Re: Second Addendum Soil and Ground-Water Investigation Work Plan
Atlantic Richfield Company Station #771
899 Rincon Avenue
Livermore, California
ACEH Case RO0000200

Re: Second Addendum Soil and Ground-Water Investigation Work Plan, Atlantic Richfield Company (a BP affiliated company) Station #771, 899 Rincon Avenue, Livermore, California. Case No. RO0000200.

enclosure: Drawing 1: Site Location Map
 Drawing 2: Site Map with Proposed Boring Locations

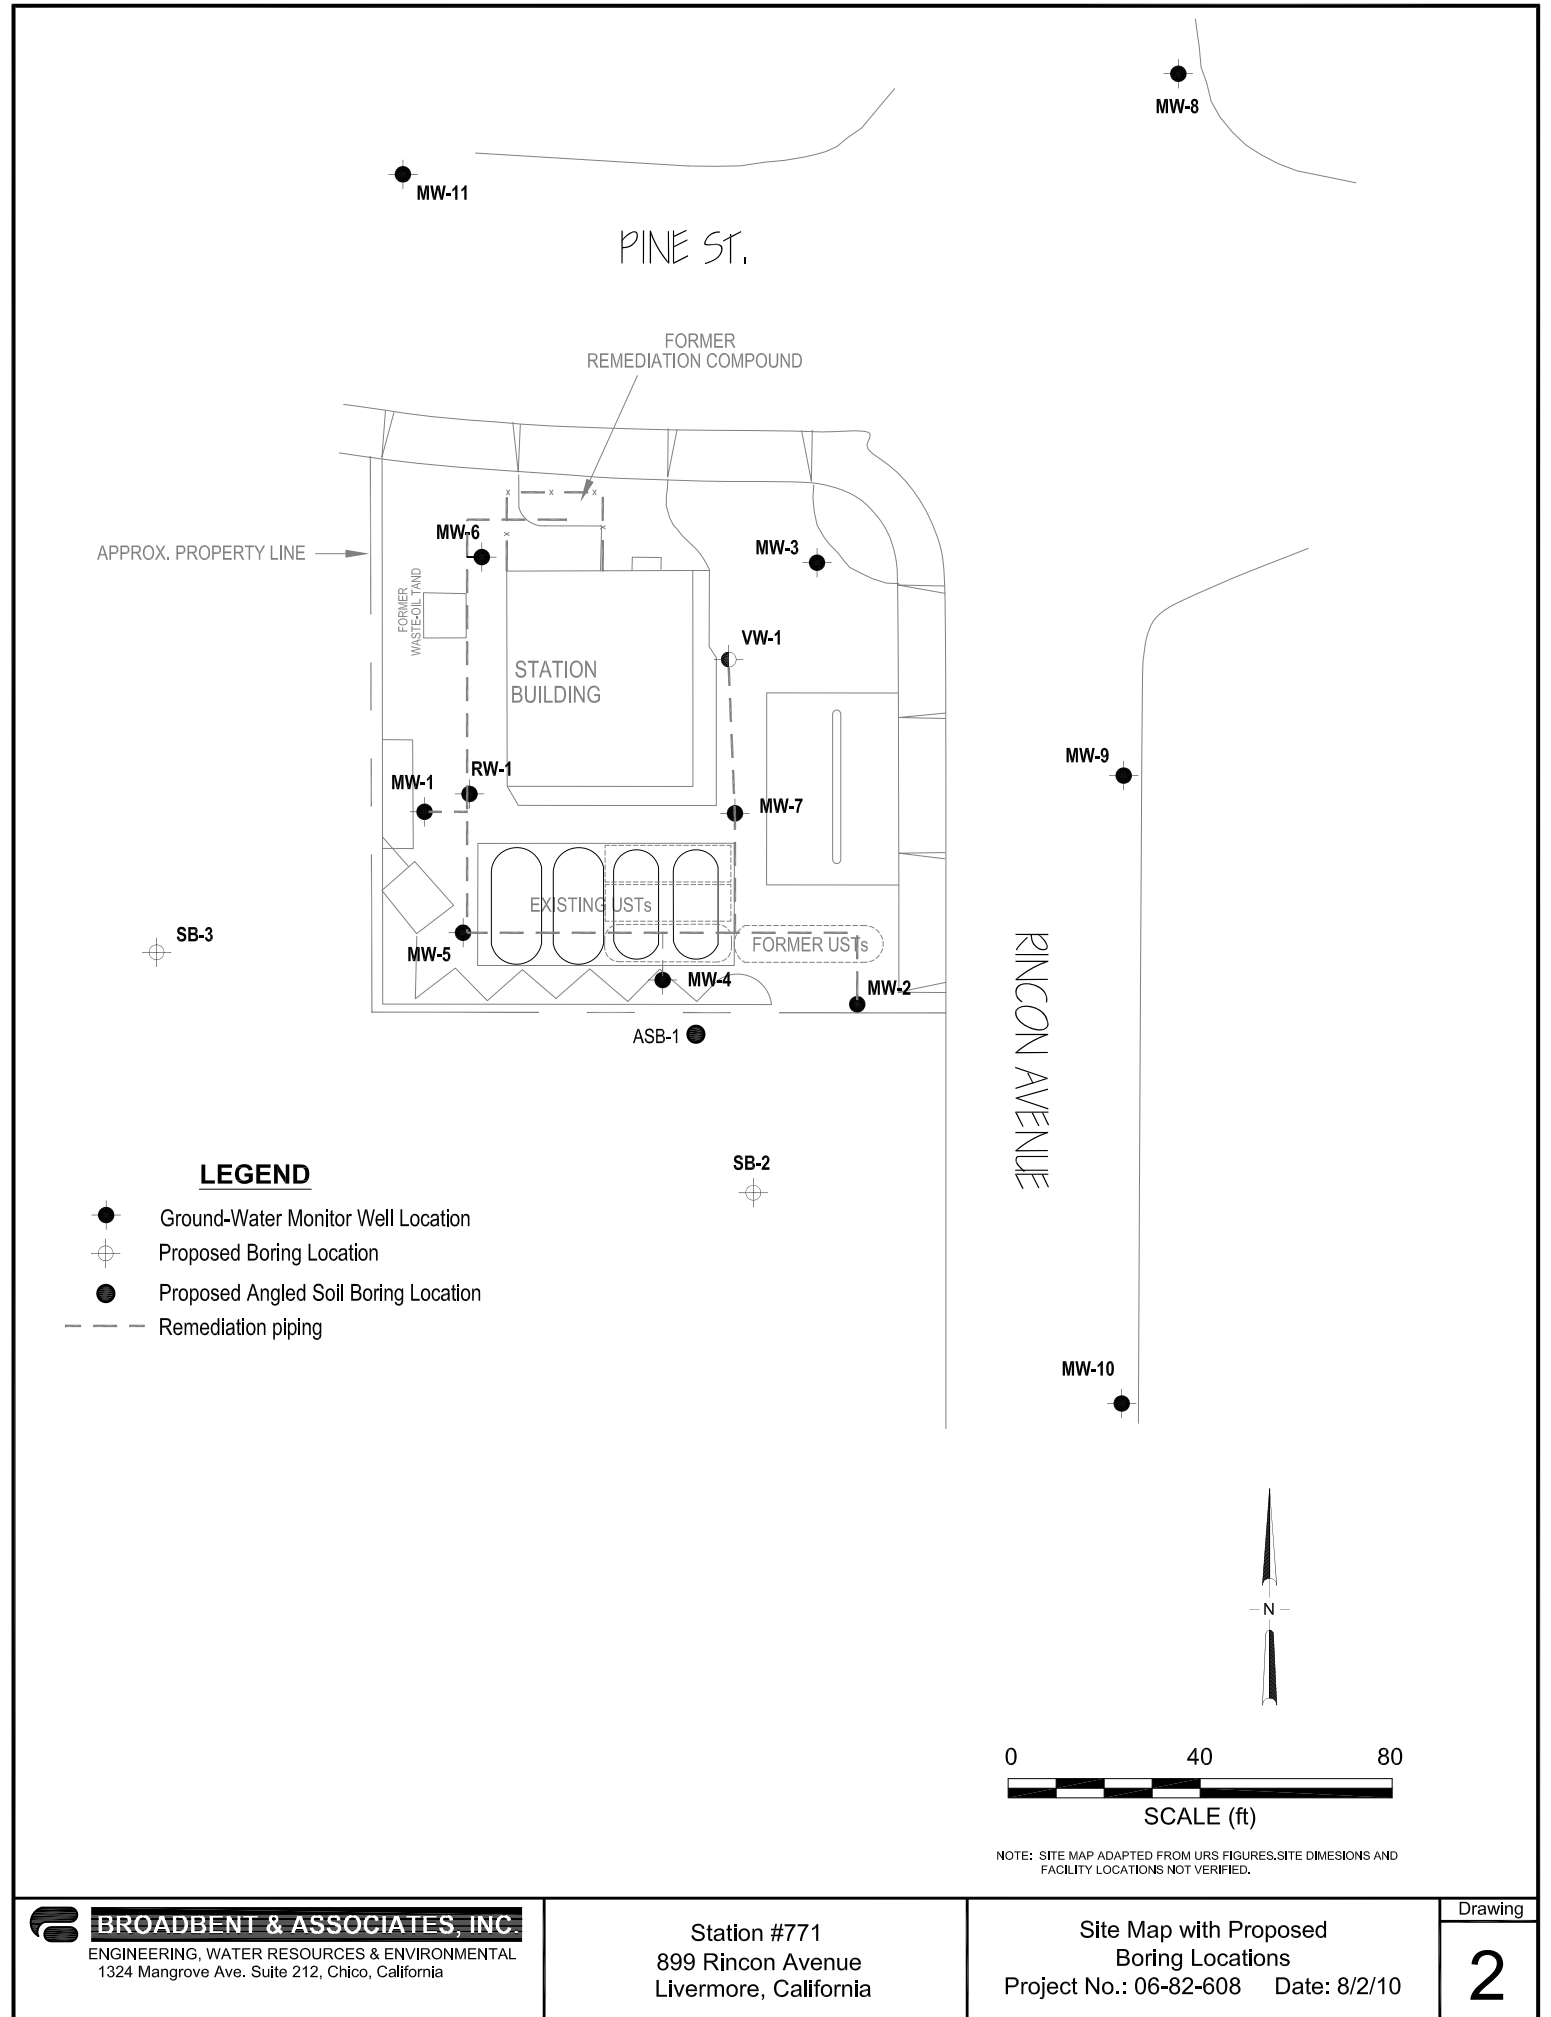
Upon further discussions with the lawyers representing the Livermore Shopping Center and ACEH, installation of the two proposed offsite monitoring wells is not the preferred scope of work for the owner of the Shopping Center. Therefore, it is proposed to install two off-site soil borings to collect one-time soil and ground-water samples. The two proposed borings, SB-2 and SB-3, will be located in the same locations as previously recommended wells MW-12 and MW-13. A Site Location Map is provided as Drawing 1. A Site Map with Proposed Boring Locations is provided as Drawing 2. Additional soil and ground-water sampling details for SB-2 and SB-3 (including laboratory analysis) will follow what was already proposed in the original Work Plan for off-site wells MW-12 and MW-13 (BAI, 2/10/2009). Due to dense soil conditions previously observed at the Site during drilling activities, it is proposed to use a hollow-stem auger drilling method for each of the soil borings. Each boring will be continuously sampled during drilling activities in order to obtain an accurate description of the lithology at each location.

discussed above, proposed soil borings SB-2 and SB-3 and angled soil boring ASB-1 are all located on the neighboring Shopping Center property. With a signed access agreement in place, BAI will execute the proposed field work. If a signed access agreement is not in place following 90 days from approval of this Second Addendum Work Plan by ACEH, further assistance with access agreement negotiations from ACEH may be requested. Upon completion of field work and receipt of the laboratory analytical report, BAI will complete a soil and ground-water investigation report for submittal to ACEH.
